LiDAR Quality Assessment Report

MO_RandolphCo_2012

Missouri Grand Randolph Co. 3rd delivery

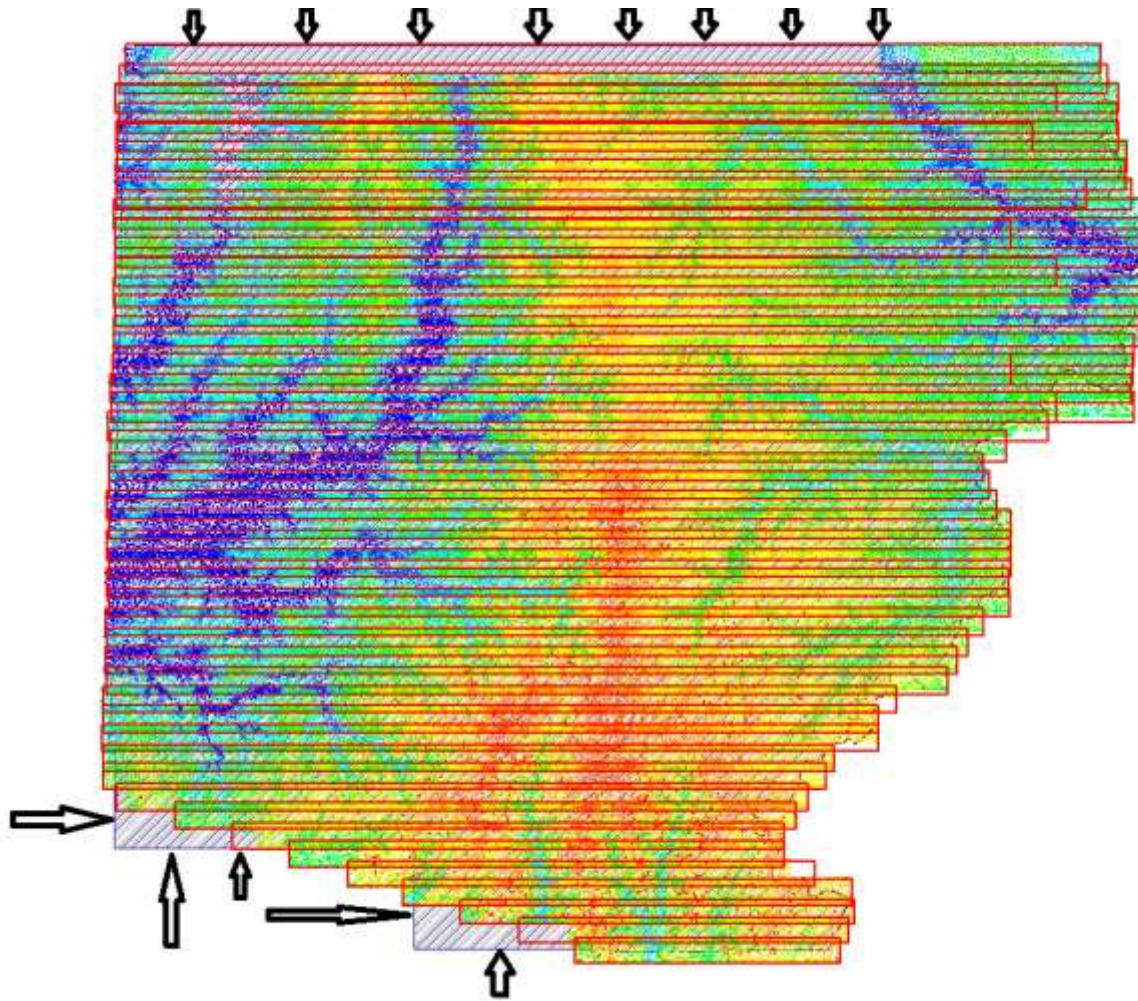
Swath FVA tests 67.9cm NSSDA with 36 hard surface points.

Swath FVA tests 10.9cm NSSDA with 35 hard surface points. point 30HS has been removed from the calculation of swath FVA.

In the Project Overview section, pg. 2 of 5, of the "LiDAR Acquisition Processing Summary" the table shown above specifies parameters used in preparing the flight plan for Randolph Co. Field of View (FOV) of 34 degrees. The Min (SAMN) and Max (SAMX) Scan Angle should not exceed + or - 17 degrees from Nadir. Scan Angles extremely exceed these parameters. The scan angles reported in LP360, -45 and 52, exceed Leica ALS- 50 II system accuracy limits of 75 degrees (FOV) + or - 37.5 degrees from Nadir.

Accuracy testing supports the data and it is the opinion of NGTOC that the data is correct and the scan angles have been recorded in error. Please explain why scan angle exceeds FOV in the project flight plan and the limits of the Leica ALS-50 II system.

Note Flying altitude is always referred to as Above Ground Level (AGL) not Above Mean Sea Level (AMSL)

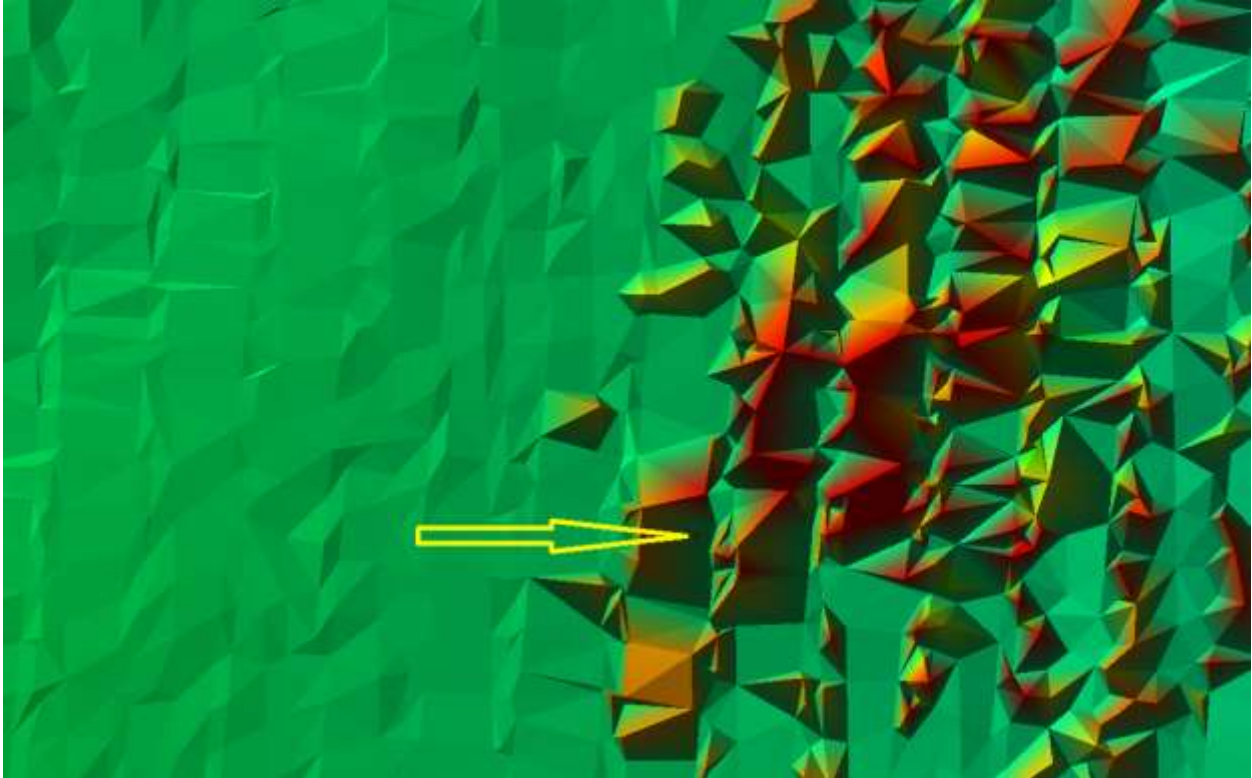
Missing swath data in gray areas. Swath data covering the north and south edge are included in Macon and Howard Cos.

Swath FVA tested at NGTOC failed. FVA tested 67.9cm NSSDA with 36 Hard Surface points. A TIN of the swath was generated in ArcGIS and tested with LP360 control points error calculator. FVA is failing at Control Check Point 30HS located @ 39° 32' 37.7882" N, 92° 23' 36.7860" W. Although the check point elevation is good, the TIN method algorithm is triangulating the swath surface at the point location 2 meters higher in elevation than the actual bare earth surface. The difference in elevation is due to the check point being surrounded by vegetation and higher ground surface elevation. The algorithm is averaging the surface of the point

location from that surrounding terrain and vegetation, thus falsifying the actual surface elevation.

The Swath tests at 10.9cm NSSDA with point 30HS removed. Point 30HS has been removed from the FVA vertical accuracy testing. See attached images of results.

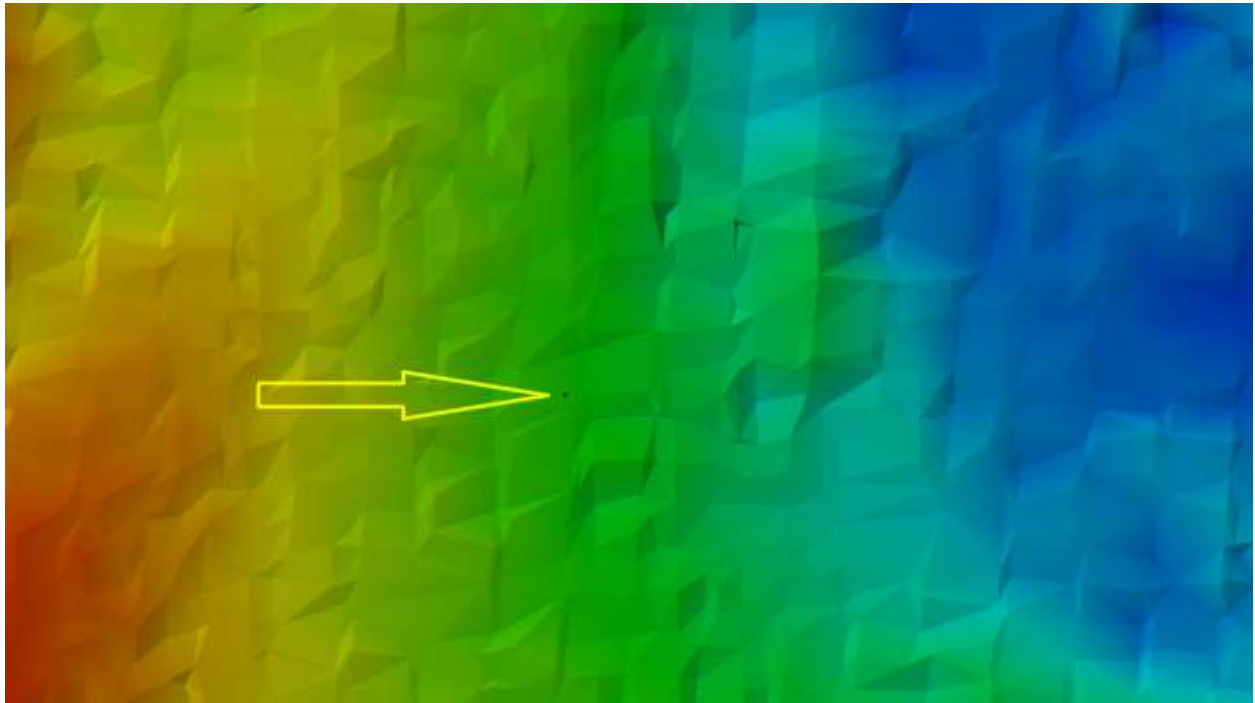
Point 30HS surrounded by vegetation points and higher bare surface elevations in swath. point is located on north south T road near vegetation and a road cut. Red and orange are higher elevations.

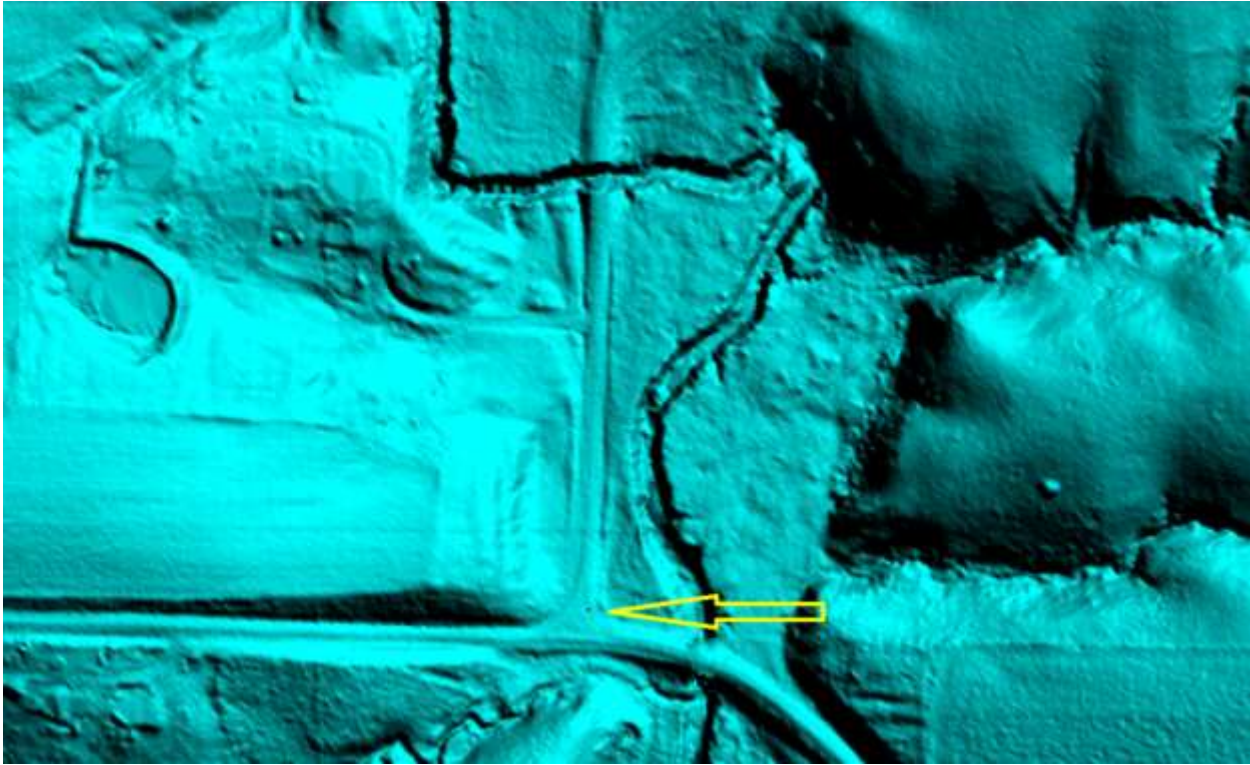
point 30HS on bare earth DEM with NAIP image drape "notice tree cover and road cut
